Work Order ID 164497

DESIGN <i>qp</i>	DRAWN BY <i>DC</i>	DART AEROSPACE LTD HAWKESBURY, ONTARIO, CANADA	
CHECKED <i>qp</i>	APPROVED <i>[Signature]</i>	DRAWING NO. D3592	REV. B SHEET 1 OF 1
DATE 07.05.31		TITLE PLATE	SCALE 1:1
A	07.01.15	NEW ISSUE	
B	07.05.31	TOOLING HOLES ADDED

DRAWING NO. D3592	TITLE PLATE	REV. B	DART AEROSPACE LTD ENGINEERING ORDER		D.E.O. NO. D3592-B-1	SHEET NO. SHEET 1 OF 1	SCALE NTS
DRAWN AJS	CHECKED	MFG. APPR.	APPROVED		DE APPR.		
DATE 08.09.11	DATE 08.09.11	DATE 08/09/11	DATE 08/09/11		DATE 08/09/11

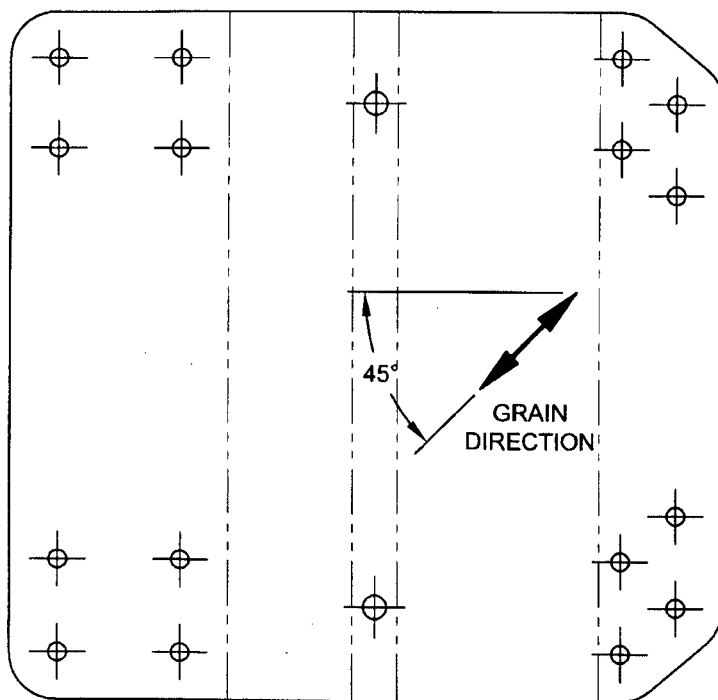
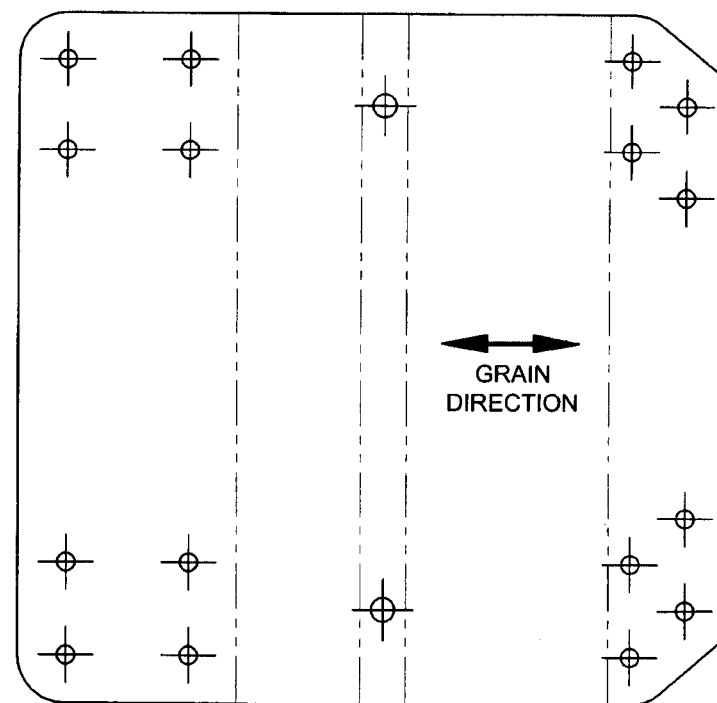
MODIFY GRAIN DIRECTION AS SHOWN BELOW TO PREVENT CRACKING WHEN WELDING AT ASSEMBLY (SEE CAR 08-026).

IS:

WAS:
